PLANNING AND ZONING BOARD

Being held at Thursday, December 05, 2019
Jarvis Hall 4505 N. Ocean Drive 33308

- 5.a Case Number 2018-L2-SPM-07: Level 2 Site Plan Modification to replace the existing swimming pool with a new rectangular shaped 5'-0" (five foot) depth swimming pool, replace an existing water feature, provide a new covered walkway in Building 3, provide a new covered walkway in Building 4, replace existing hardscaping and concrete pathways, construct new hardscape/landscaping throughout the property, relocate existing trees on site, construct a new volleyball court, construct new fencing along the east side of the property and complete interior renovations.

- 5.b Case Number 2019-L2-SPM-01: Level 2 Site Plan Modification for 100 Commercial Blvd to add one (1) 500 sq. ft. (square foot) interior mezzanine to the existing one (1) story building.

TITLE
PAVING, GRADING & DRAINAGE PLAN

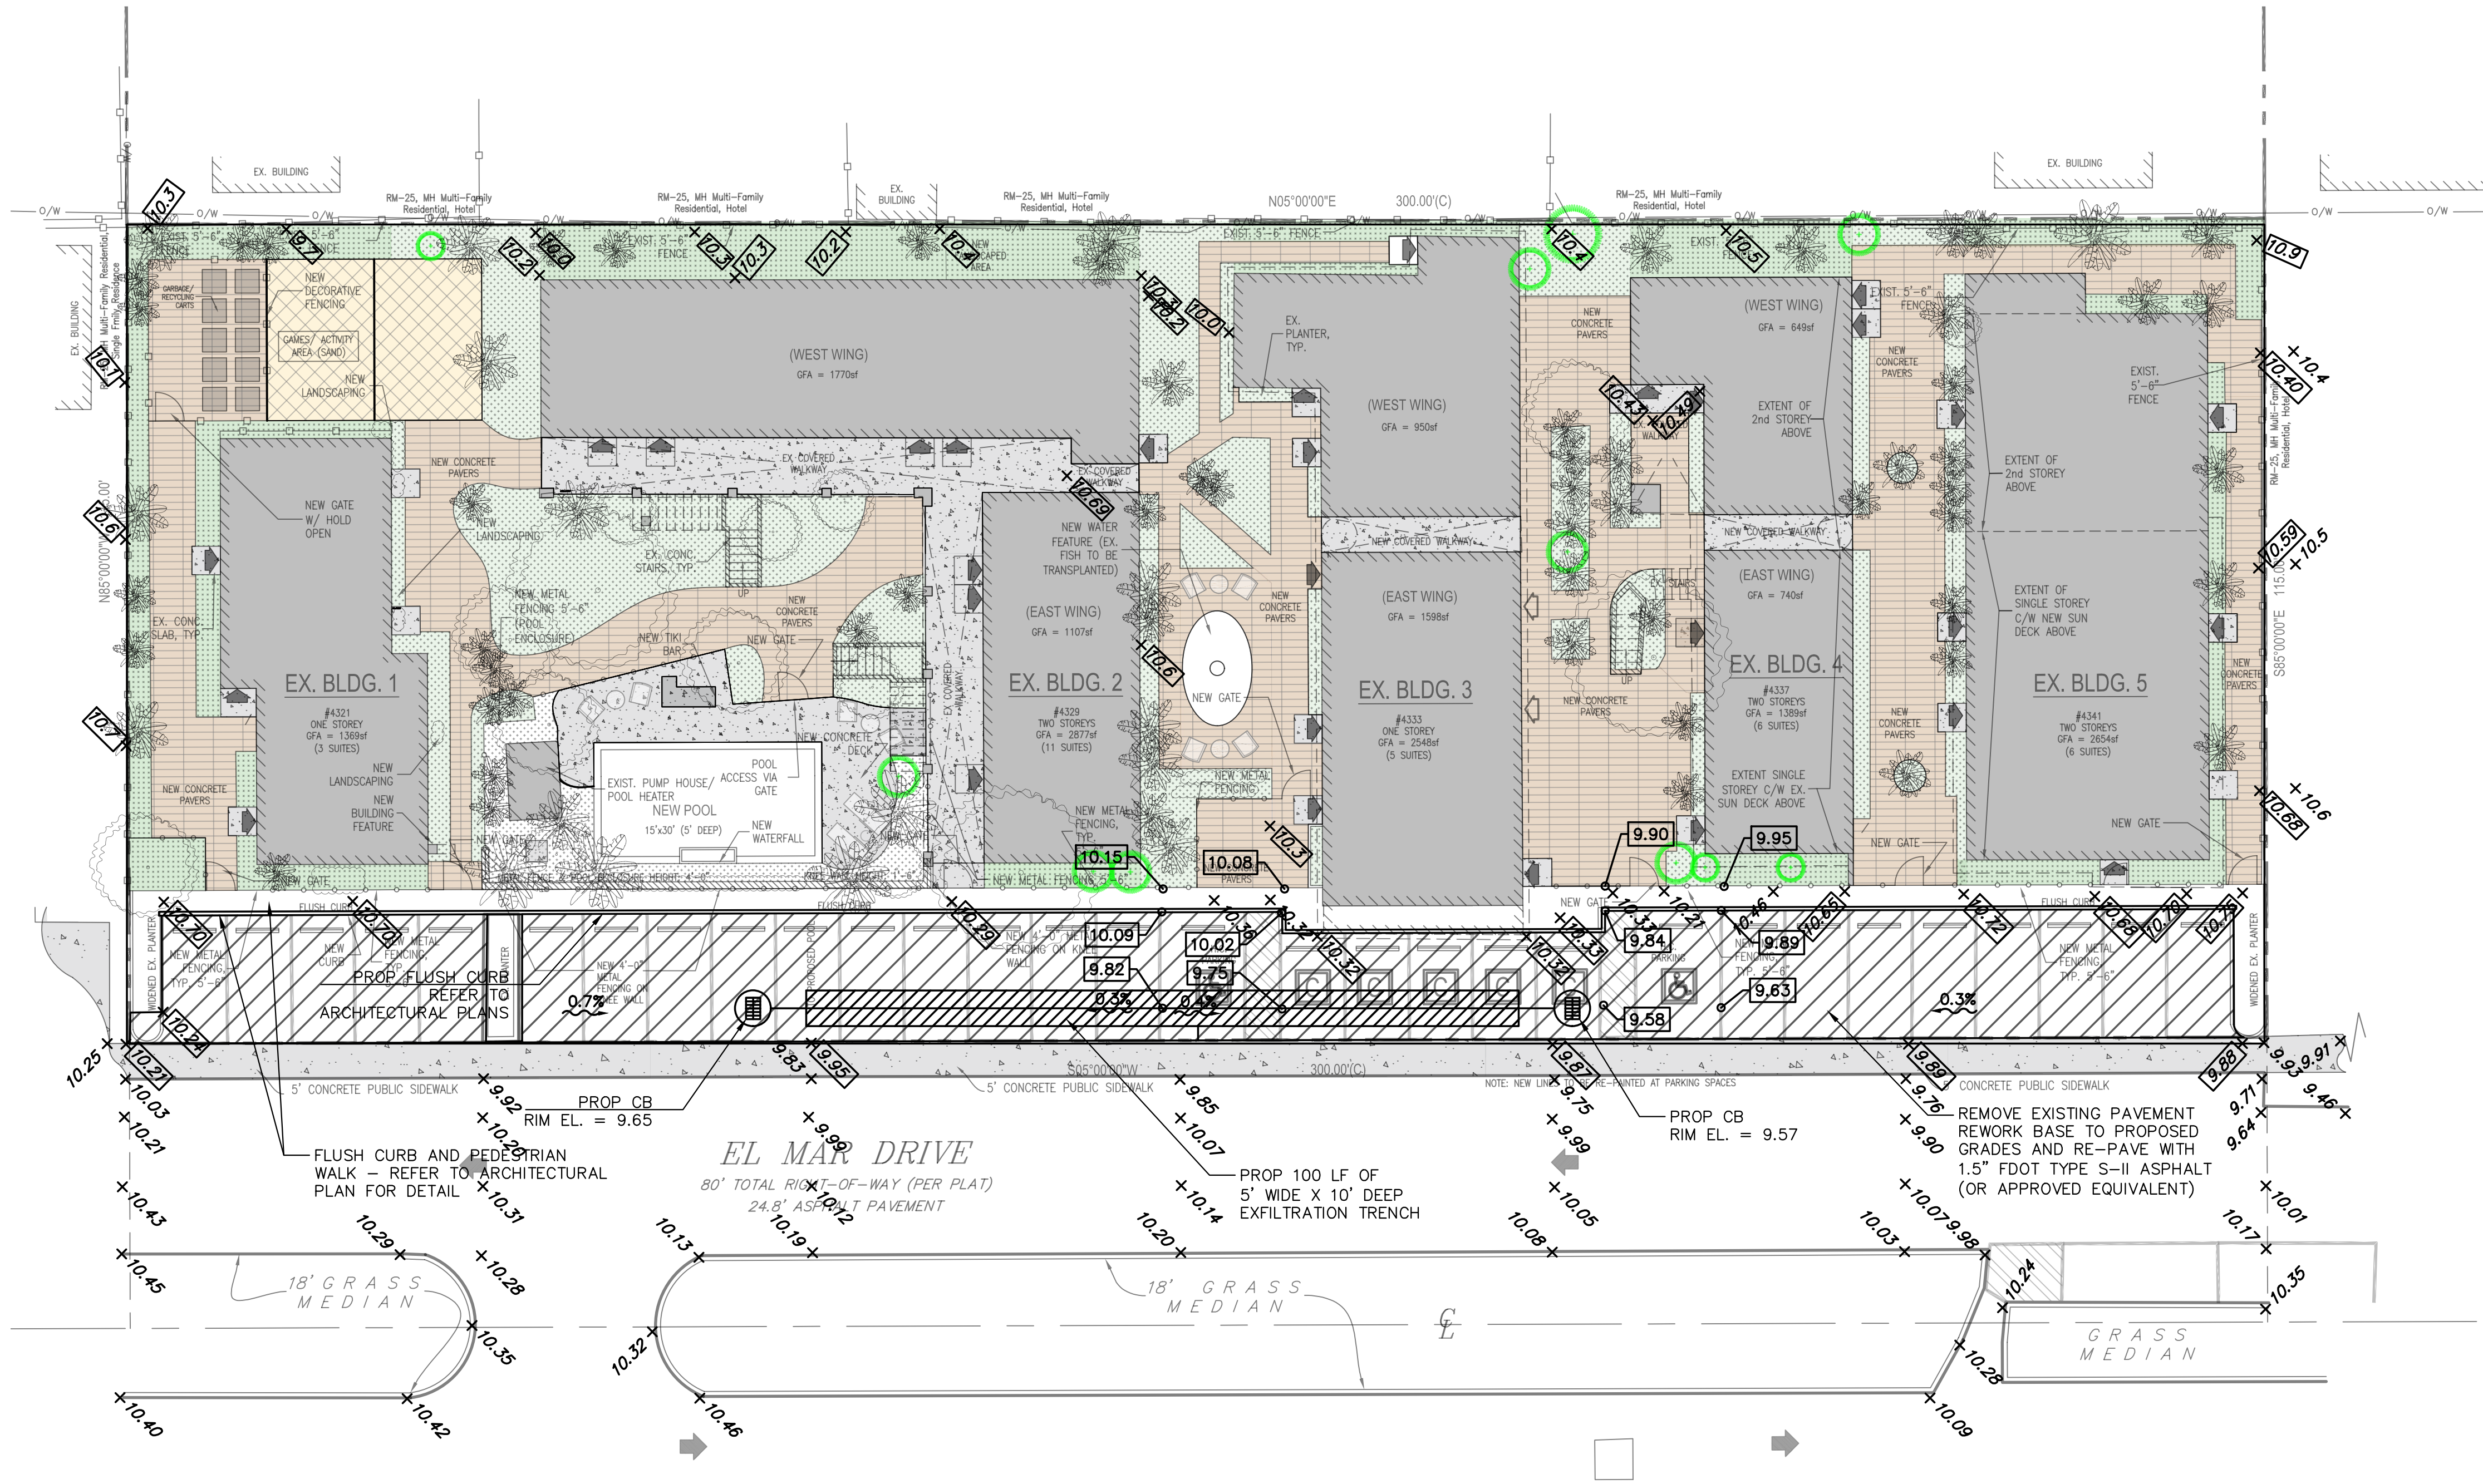
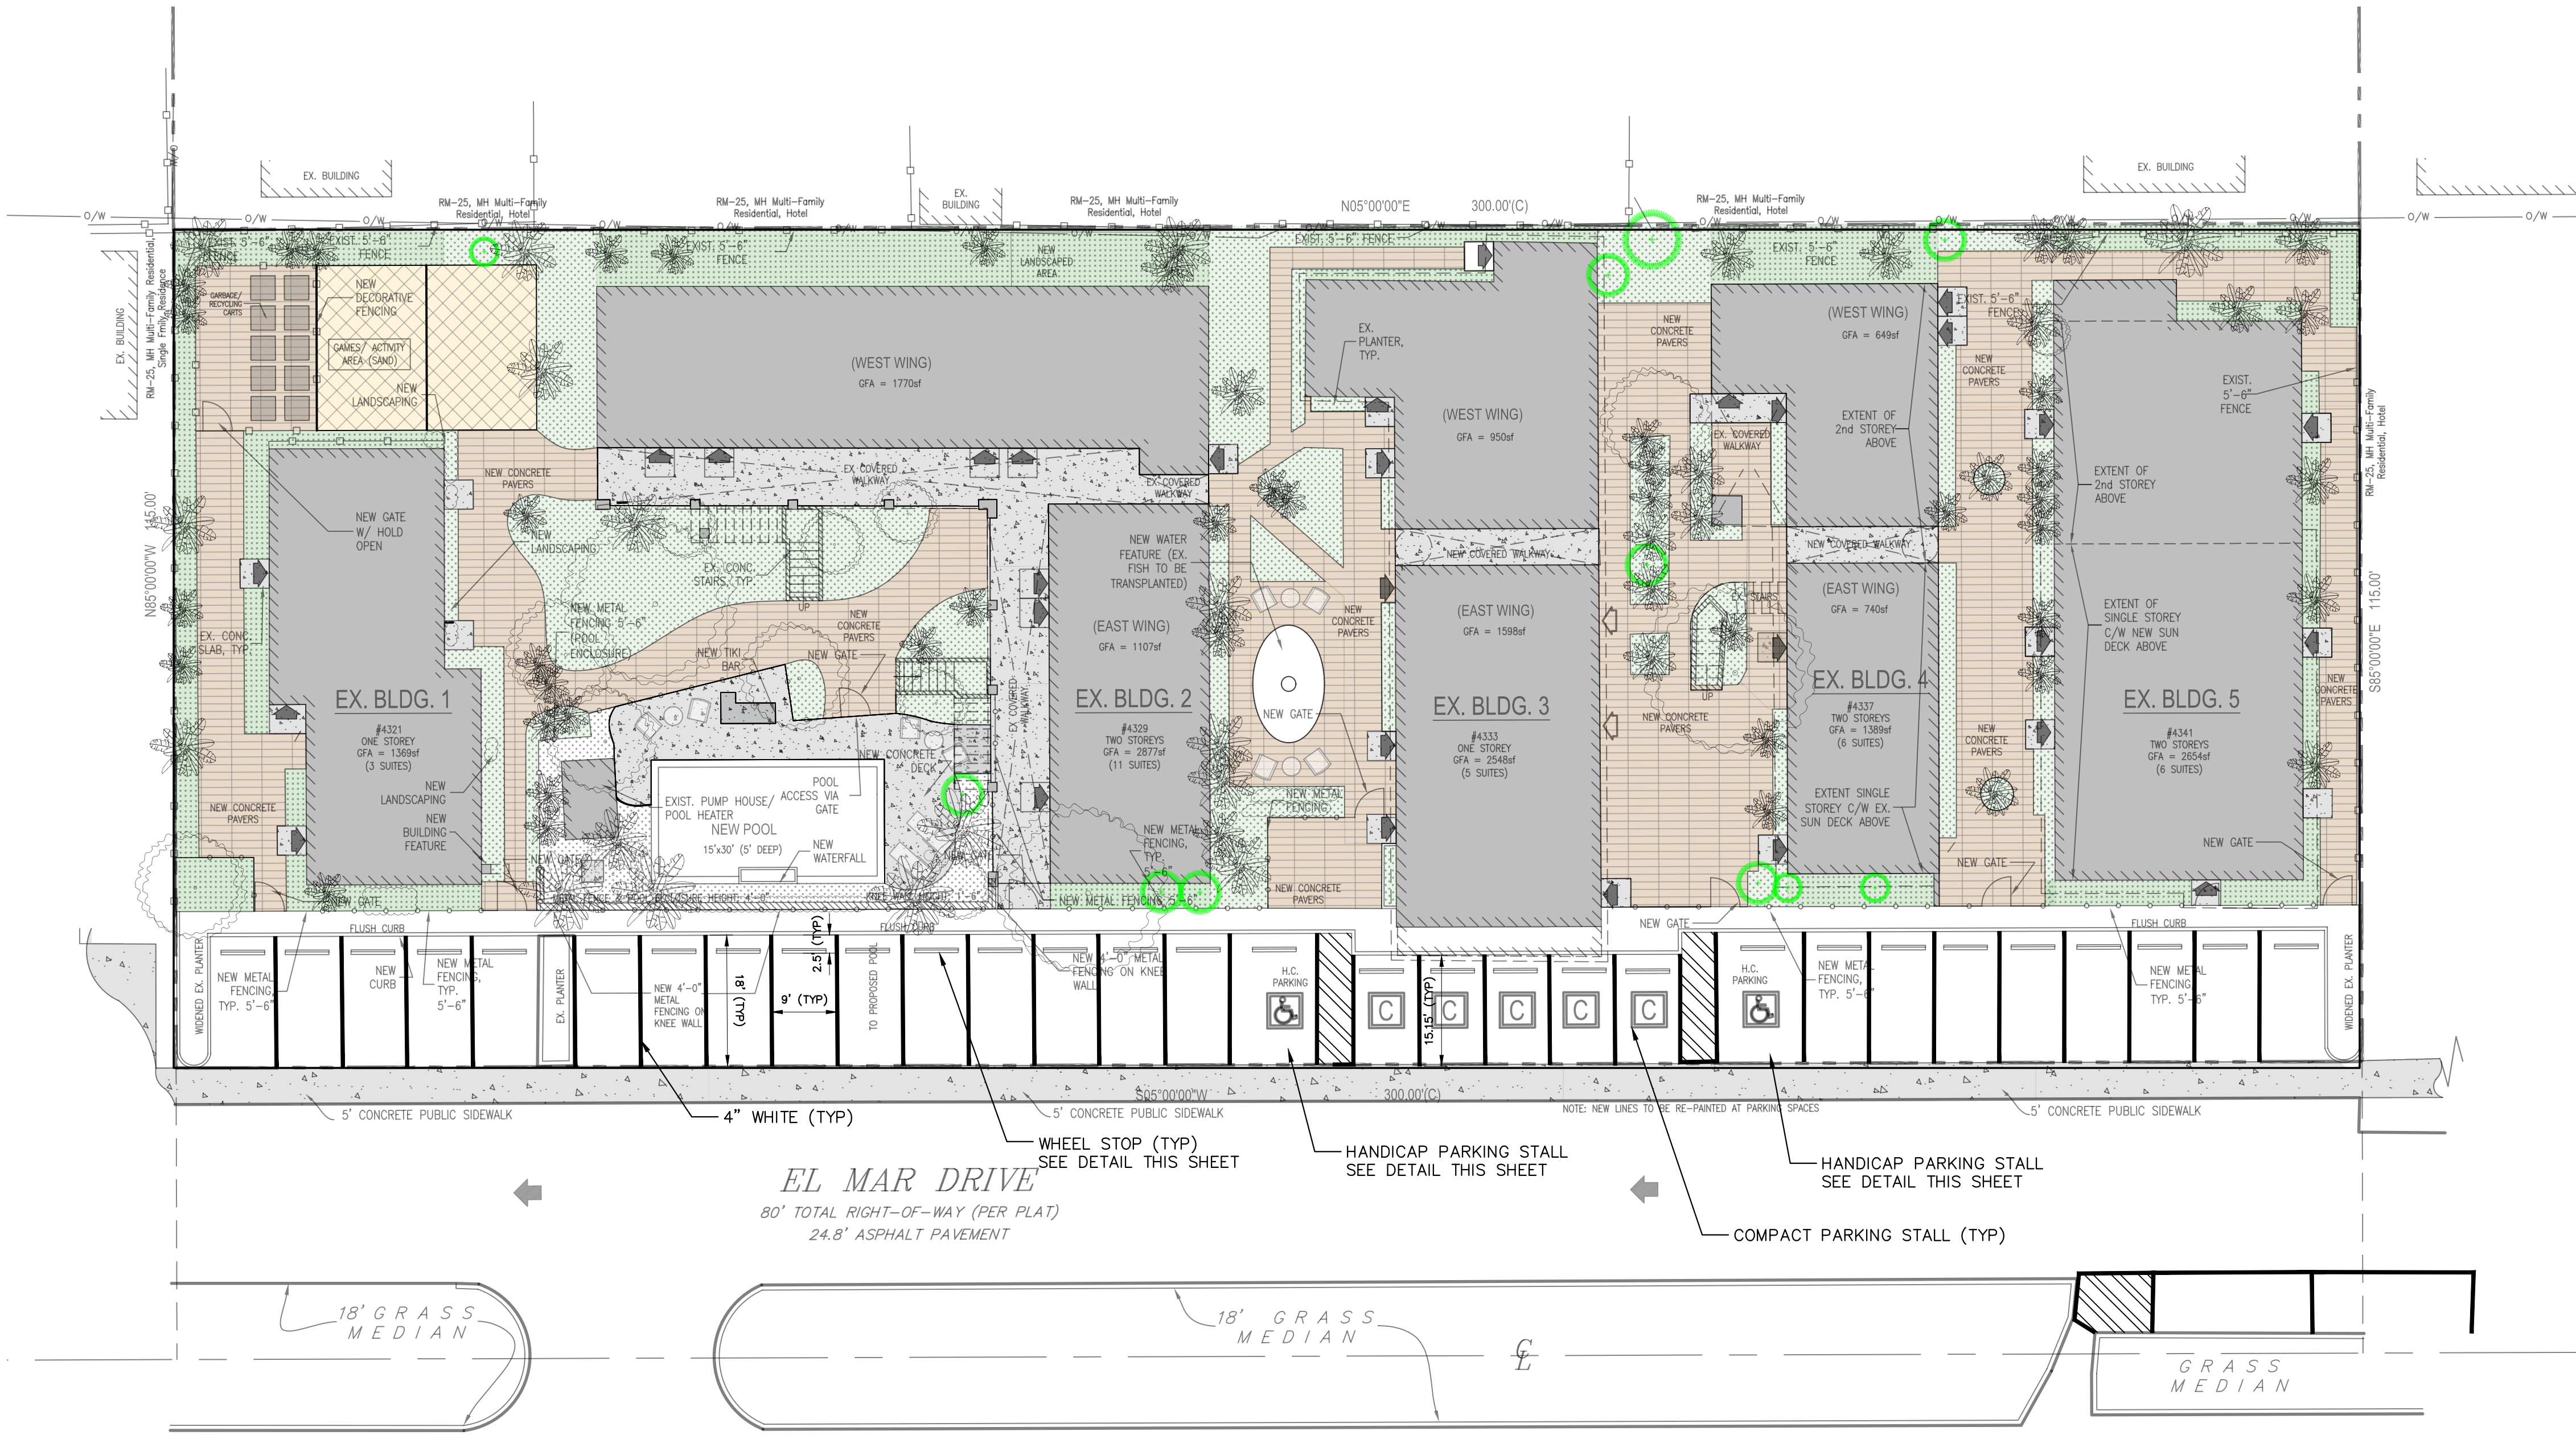
- o Topo and grading provided but the slopes in handicap parking and access isles are shown to exceed 2%. Revise grading and provide additional grades on each corner of the handicap parking space and access isle for clarification.

- o Broward County Surface Water Management License will be required at time of permitting.
- o Revise note 4 on plan C-1 which references the City of Fort Lauderdale standard details. This project is located in the Town of Lauderdale By-The-Sea not Fort Lauderdale.

- o Provide information on plan C-1 for proposed mill and resurface. Depth of mill and thickness and type of proposed asphalt for resurfacing. Asphalt reference is to FDOT Type S-II asphalt however FDOT only uses type SP asphalts. Revise reference to FDOT Type SP-12.5 for 1.5" of asphalt.

7. Broward County Surface Water Management License will be required at time of permitting.
8. Revise note 4 on plan C-1 which references the City of Fort Lauderdale standard details. This project is located in the Town of Lauderdale By-The-Sea not Fort Lauderdale.

9. Provide information on plan C-1 for proposed mill and resurface. Depth of mill and thickness and type of proposed asphalt for resurfacing. Asphalt reference is to FDOT Type S-II asphalt however FDOT only uses type SP asphalts. Revise reference to FDOT Type SP-12.5 for 1.5" of asphalt.
